RE: Grosvenor Building, Cavendish Street, Manchester

Thomasons received instruction from Simon Glass of Turner & Townsend on behalf of Manchester Metropolitan University to inspect and comment on cracking defects noted to the north elevation of the Grosvenor Building on Cavendish Street, Manchester.

Remedial proposals have previously been advised by Curtins Consulting Engineers but following a request from the Manchester City Council Conservation Officer further advice is being sought from a Conservation Accredited Engineer. Jane Entwistle, a Conservation Accredited Engineer, visited the building on 16 May 2023 for inspection purposes.

West gable of north elevation

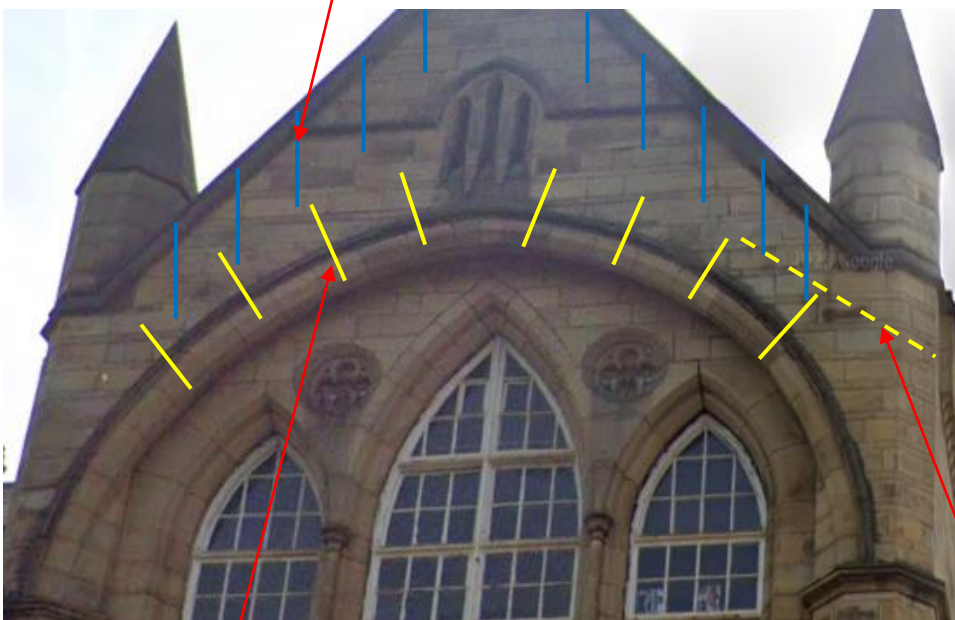
During our inspection we noted that there was a gap between the back of the arch in the west gable which had previously been filled and had substantially lost its fill. The variation in width of the gap, together with loss of mortar fill, indicated that this gap was not an original feature and that it has continued to move.

At the western end of the gable there was a stone pinnacle. Cracking had occurred between the side of the pinnacle and the apex of the gable; this had been repointed by the time of our inspection but photographs provided for our consideration showed that this cracking had previously been slate packed and repointed. It was evident from the earlier photographs that this cracking was continuing to open.

At the eastern side of the east gable similar cracking was noted between the pinnacle and the apex of the gable. This was not as pronounced as that noted at the western side. On this gable it was also noted that there was some gapping between the coping stones of the gable.

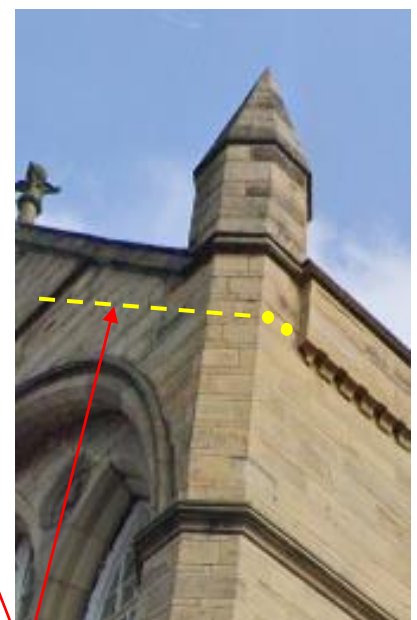
The cause of the outward movement of the arch of the west gable is most probably due to insufficient tying between the outer stone leaf and the inner leaf of the wall. It is anticipated that this movement will continue, albeit slowly, unless measures are taken to arrest this movement. We concur with Curtins that Helifix anchors will be suitable products to use in this situation. If the gap was not present we would recommend the use of CemTies but we are concerned that there could be a significant loss of grout in this gap; we therefore consider that the appropriate product for this location will be the Helifix SockFix installed at an angle and extending 450mm up into the wall behind the arch.

The outward movement of the pinnacle is likely to be the result of a combination of spreading of the arch and downward sliding of the coping stones on the steep gable. We understand that when explored it was found that the fixing holes in the top of the coping stones contained no indication of there ever having been any fixings down into the apex of the gable. It will therefore be prudent to stitch down the coping stones using 10mm Helifix CemTie anchors in order to prevent further sliding; this should be undertaken to both gables.

As the outward movement of the pinnacle appears to be of an ongoing nature it is considered that it should be stitched back to the apex of the gable. We consider that the appropriate anchors for this will be 16mm Helifix SockFix anchors in 40mm holes. Two anchors should be installed from the western (Higher Ormond Street) elevation; the anchors should be angled upwards across the crack and extend at an angle slightly lower than the line of the coping.

10mm Helifix CemTie anchors, 900mm long, 1no. per coping stone (Note: this repair applies to both gables)

8no. 8mm Helifix SockFix anchors in 20mm holes. Anchors to be installed in alternate arch stones and angled upwards to cross gap and anchor 450mm into wall behind arch

2 no. 16mm Helifix SockFix anchors in 40mm holes angled below the coping. Anchors to be inserted from west elevation of pinnacle
